From: Detterman, Mark, Env. Health
Sent: Tuesday, November 29, 2011 3:27 PM
To: 'Paul Parmentier'
Cc: 'Kaplan, Scott'; 'Murray, Dave'; 'Kristene Tidwell'
Subject: RE: Paco Pump Groundwater sampling RO 000302

PROPOSED 2011 GROUNDWATER SAMPLING/MONITORING

Location: Paco Pumps
9201 San Leandro Street

Proposed Additional GW Monitoring Wells

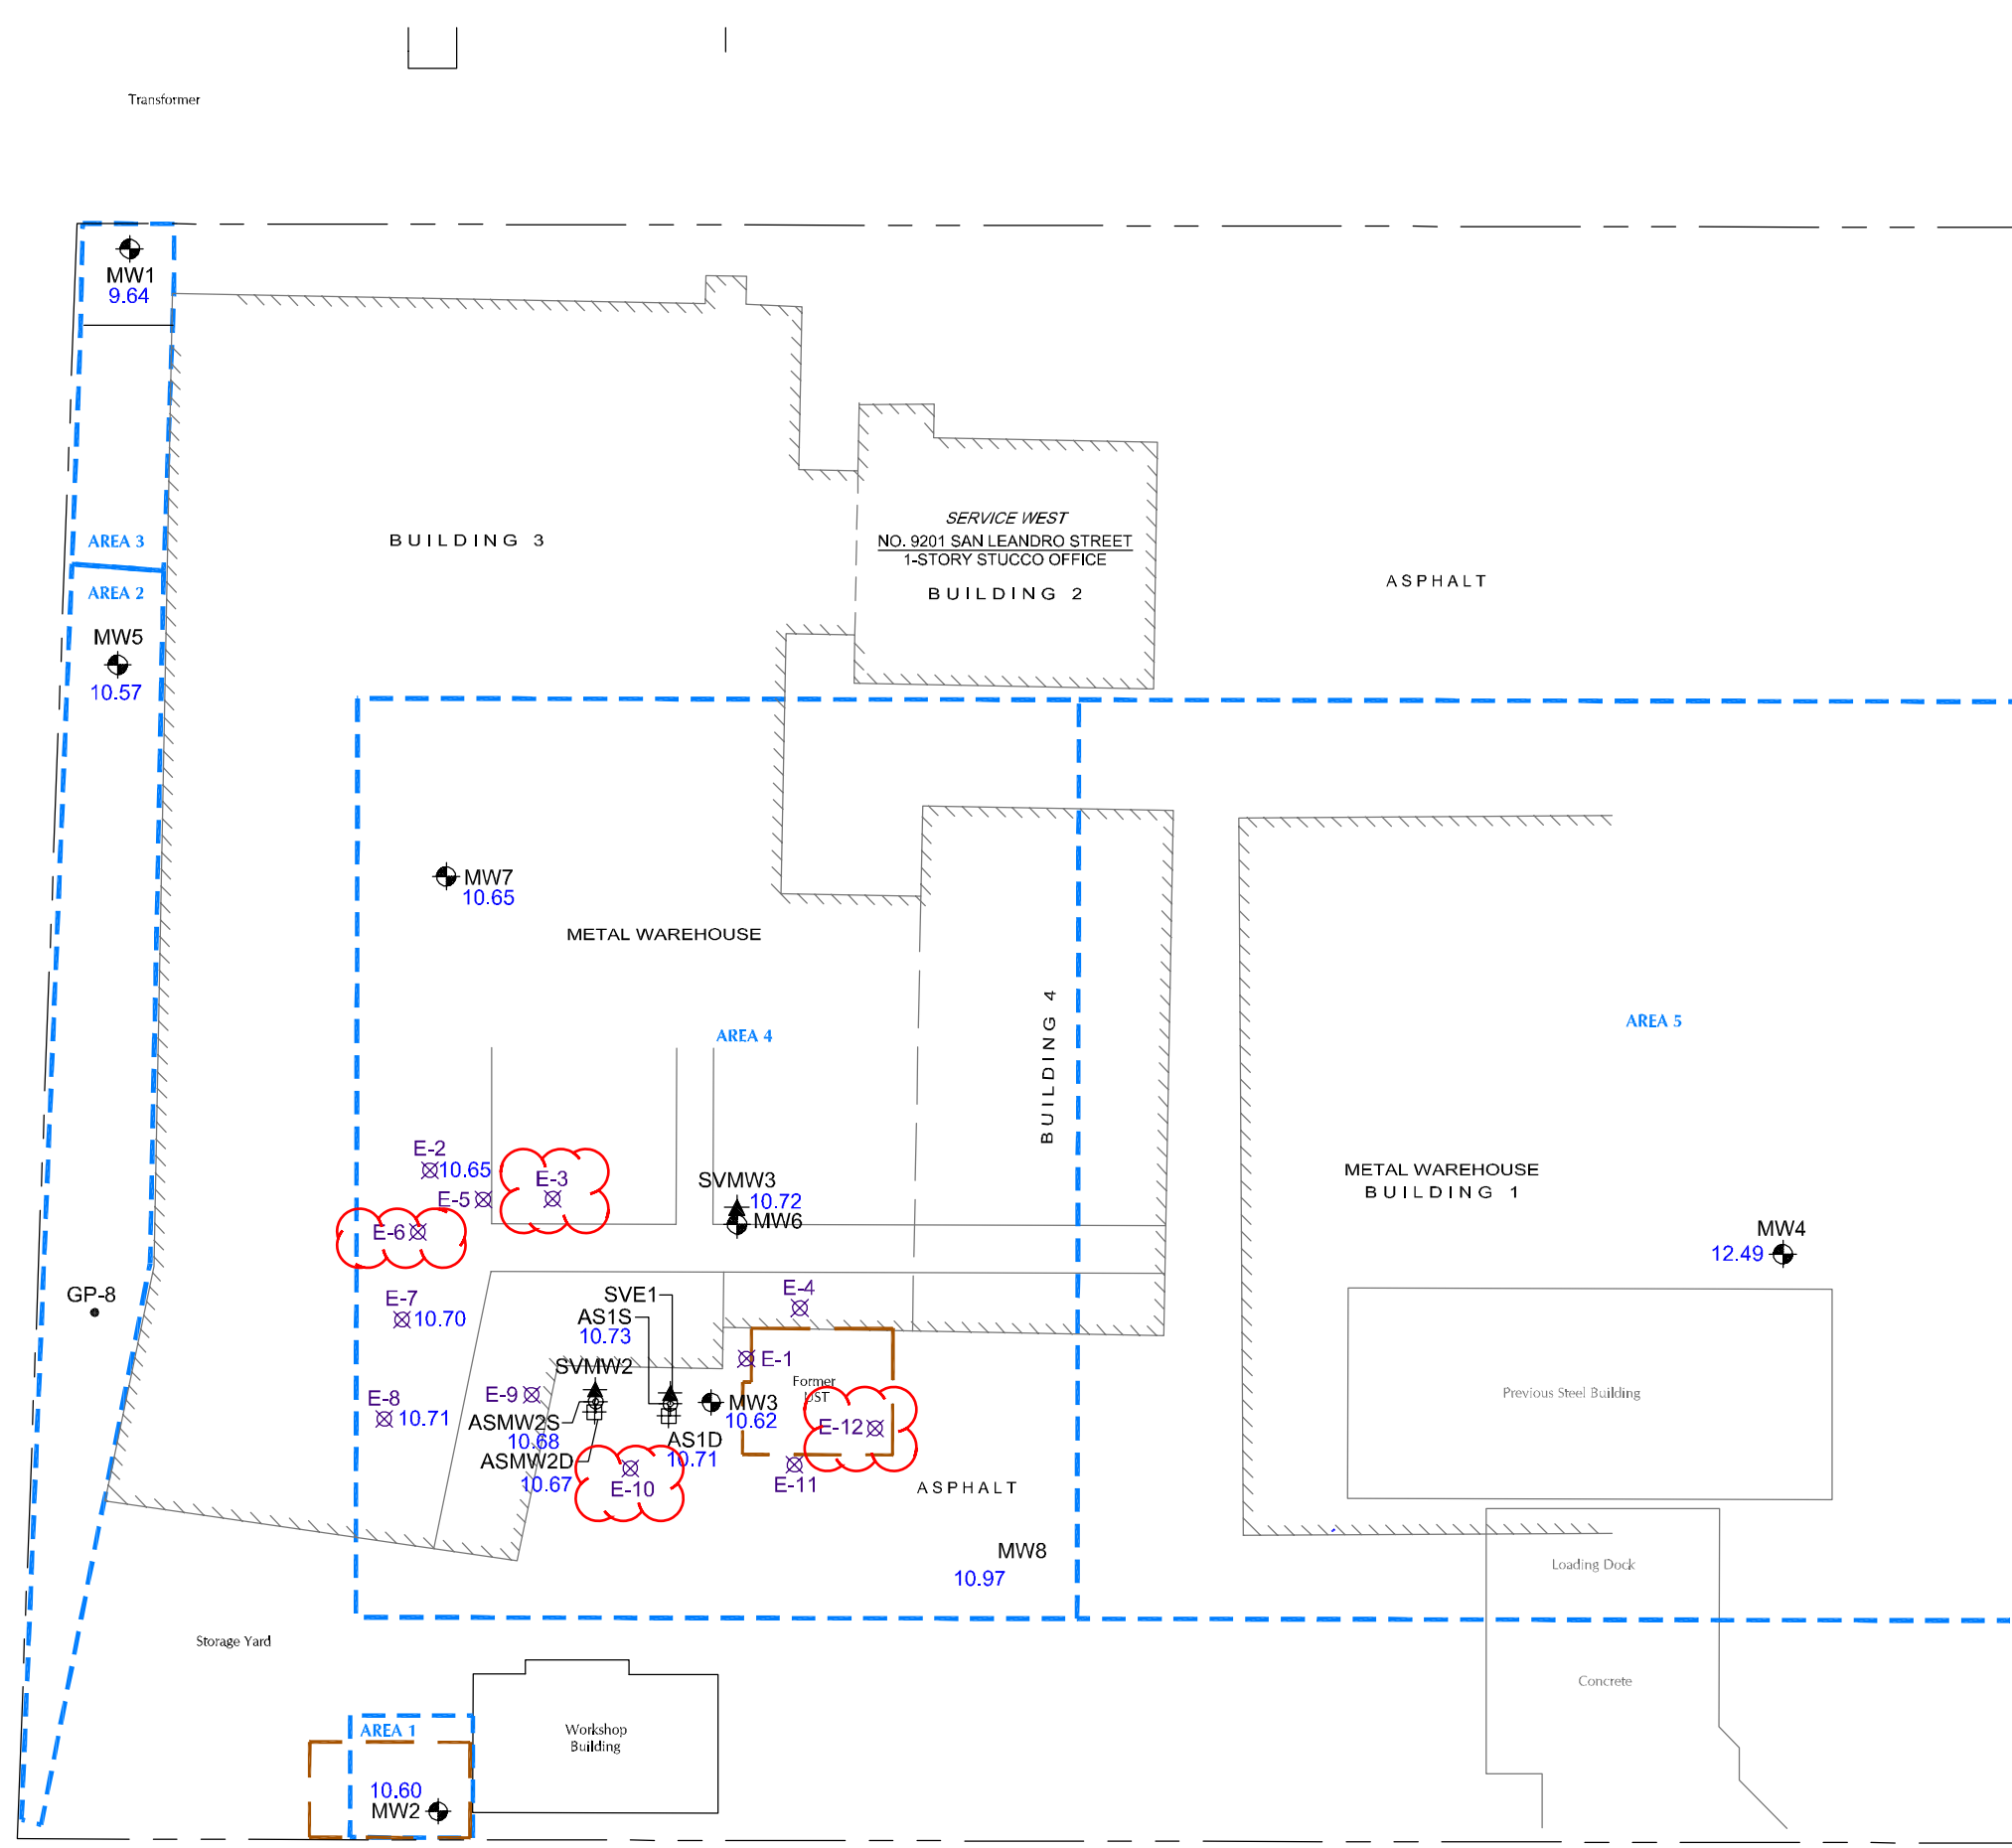
Paul,
Thanks for the email and status update. While I understand the interest in limiting the costs associated with a groundwater monitoring event, I also believe a site wide sampling event will be very useful since some of the wells proposed for gauging only haven't been sampled in a year or more since the DPE event; thus the event should include all of the wells. I'm also hopeful that with the data we could limit the number of wells; converting some to semi-annual or annual intervals thereafter.
Best,

In addition to the monitoring wells previously sampled semi-annually, we would add wells E-3, E-6, E-10 and E-12 to the sampling (See attached figure). Wells E-1, E-4, E-5, E-9, and E-11 would not be considered as critical to understanding site conditions and are proposed to be gauged, but not sampled.
